INSPECTION AND REPLACEMENT OF NOSE GEAR DRAG LINKS

Lancair IV, IV-P, IV-PT, and Legacy

SB078-0722

Figure 4

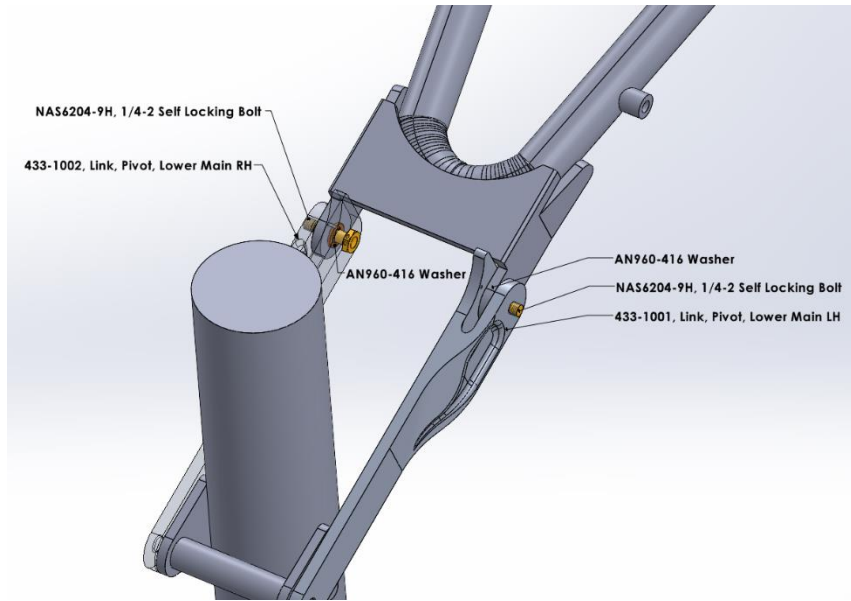
- 7.2** Procedure (See Figure 2 and 4):
- 7.2.1** Lubricate lightly and install the new 433-1001 Lower Drag Link LH and 433-1002 Lower Drag Link RH.
- 7.2.2** Install the new lower links to the over center link using NEW NAS6204-7H Self Locking Bolts (head on inside of the assembly, threads going outboard) and AN960-416 Washers.

- 7.2.3** Before attaching the 433-1001 & 433-1002 Lower Drag Links to the nose strut, torque the above bolts to 90-100 in./lb. and ensure each of the two lower links will pivot on the upper link through the full range of movement required during gear retraction.

If the full range of motion is achieved, safety wire both NAS6201-9H Self Locking Bolts to the corresponding Lower Drag Link. A small hole for safety wire can be found on the curvature of the stop.

NOTE: The Upper Over center Link Assembly has been upgraded to a stronger part by SB074-0111. If you have not complied with this service bulletin, it is recommended that SB074-0111 be incorporated at this time.

SB074-0111 applies to both over center link tab configurations shown in Fig. 4, SB074-0111 also addresses the installation of a Hydraulic actuator end with a spherical bearing. For further details on the inspection please refer to SB074-0111.
